STAFF REPORT
COMMUNITY DEVELOPMENT DEPARTMENT

SUBJECT: H-2022-0015
 Bountiful Commons – MDA, PFP

Modification to the existing Development Agreement (Linder Mixed Use - Inst. #2018-052340) to update the conceptual development plan & building elevations; and combined preliminary and final plat consisting of three (3) building lots on 2.20 acres of land in the C-C (Community Business) zoning district.

B. Proposed Conceptual Development Plan (NOT APPROVED) & Elevations to be Included in Amended Development Agreement

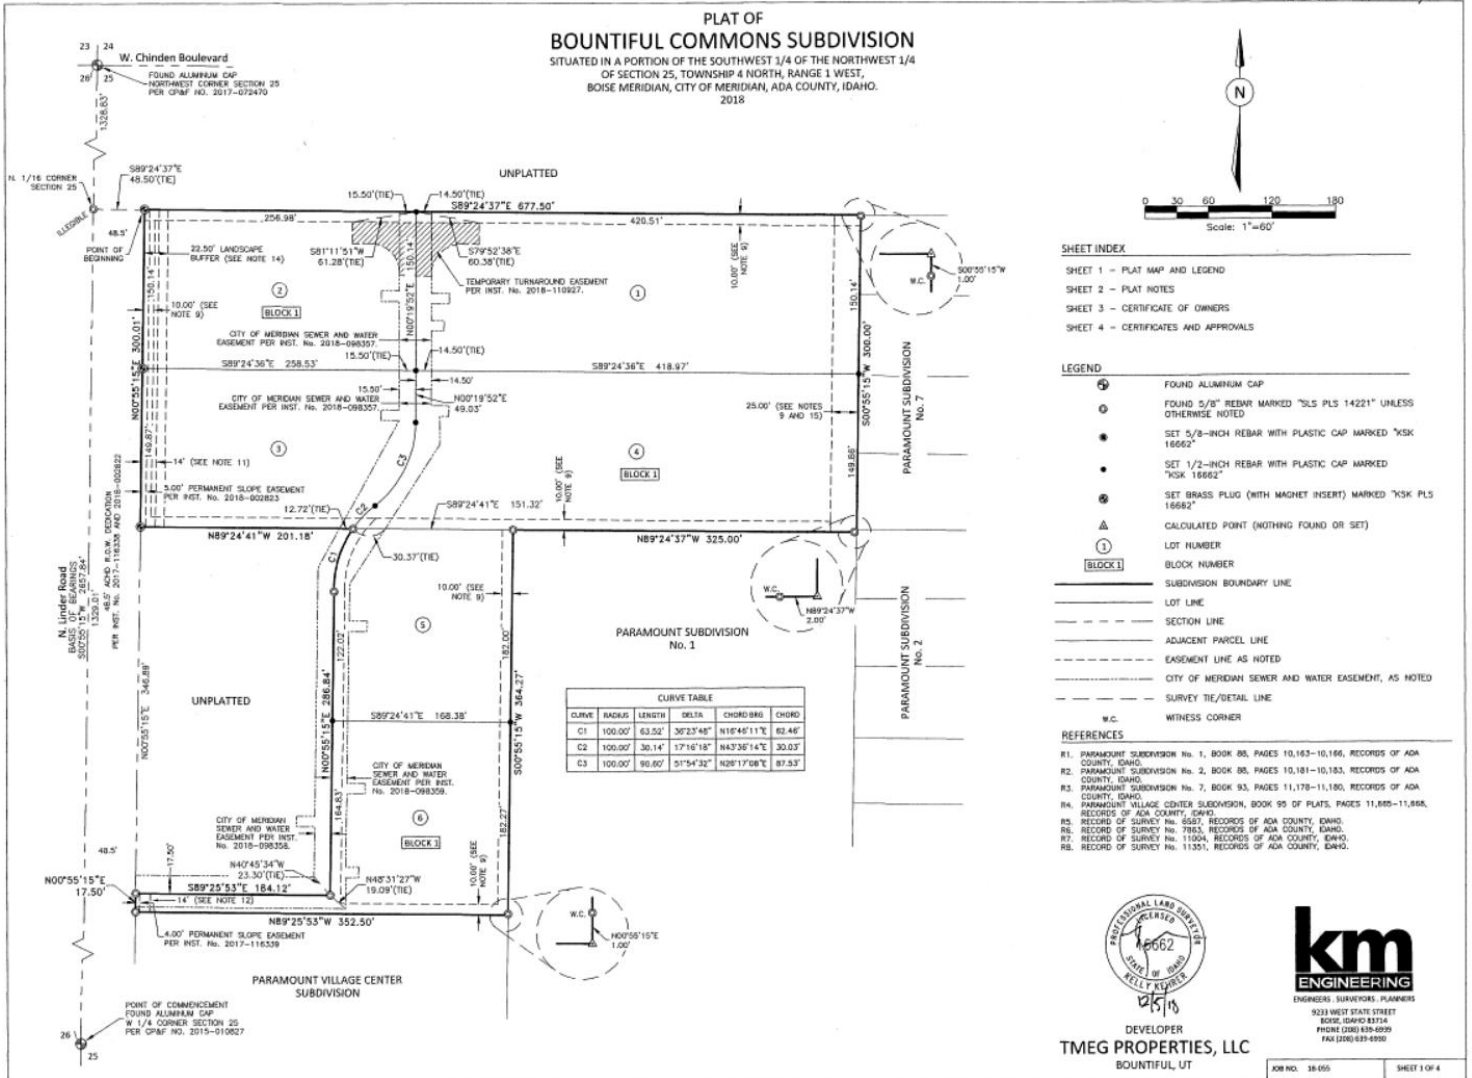
The proposed development plan includes four (4) multi-tenant commercial/office buildings with individual outdoor plazas at the rear of each building, a pedestrian walkway around each building with a connection in between the two northern buildings and two southern buildings, and surface parking internal to the site. Conceptual elevations for the proposed structures are also included (see Section VII.B below). As part of the modification, the Applicant proposes to remove the conceptual elevations for the Chili's restaurant and the event center.

A north/south backage road exists along the west boundary of this site that provides an access from the collector street (W. Cayuse Creek Dr.) to the north to Linder Rd. at the south boundary of Bountiful Commons Subdivision. Staff is concerned the ten (10) parking spaces depicted on the site plan along the west boundary of the site will create a safety hazard by vehicles backing out into traffic; therefore, Staff recommends these spaces are removed from the plan.

An existing provision of the DA (#5.1b) requires a minimum of 5% of the development area to be developed with supportive and proportional public and/or quasi-public spaces and places. Based on 2.93 acres, a minimum area of 0.15-acre (or 6,382 square feet) would be required. In mixed use designated areas where multiple commercial and/or office buildings are proposed, the Comprehensive Plan also desires buildings to be arranged to create some form of common, usable area, such as a plaza or green space. To create more of a shared common usable area as desired, Staff recommends instead of individual outdoor plaza areas for each building, the parking areas in between Buildings A & B and C & D are removed and a plaza/green space is provided in these areas with seating, landscaping and shade structures.

Note: The conceptual development plan depicts a total building square footage of 31,488+/- s.f. between four (4) buildings. For a commercial/office use in a commercial district, a minimum of 63 off-street parking spaces would be required; a total of 154 spaces are proposed. Even with removal of 34 spaces as recommended, a total of 120 spaces will still be provided, which Staff believes will meet the needs of the development.

Staff is generally supportive of the proposed modification to the DA with the recommended changes to the conceptual development plan noted above. Staff recommends the Applicant revise the plans to incorporate these changes and submit a copy of the revised plan to the Planning Division at least 10 days prior to the City Council hearing.

Staff recommends the Applicant revise the conceptual development plan depicted in Section VII.B to incorporate the changes noted in Section V.A and submit a copy of the revised plan to the Planning Division at least 10 days prior to the City Council hearing.

E. Proposed Final Plat (dated: 2/4/2022)

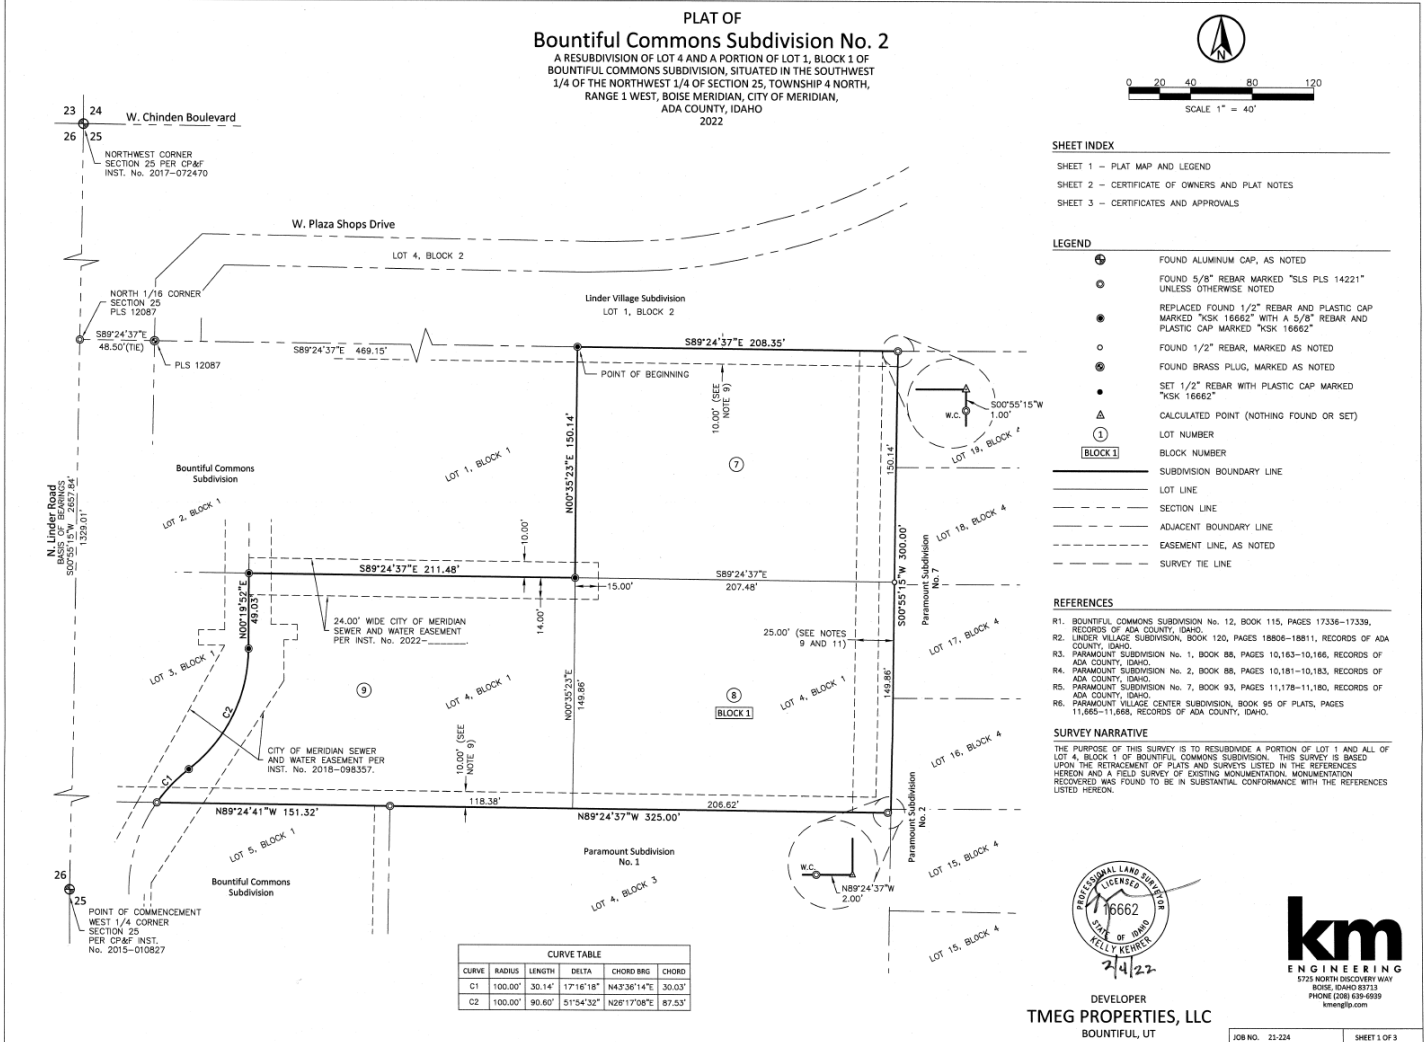
2. The final plat shall include the following revisions:
 - a. Include the recorded instrument of the City of Meridian sewer and water easement graphically depicted on Sheet 1.
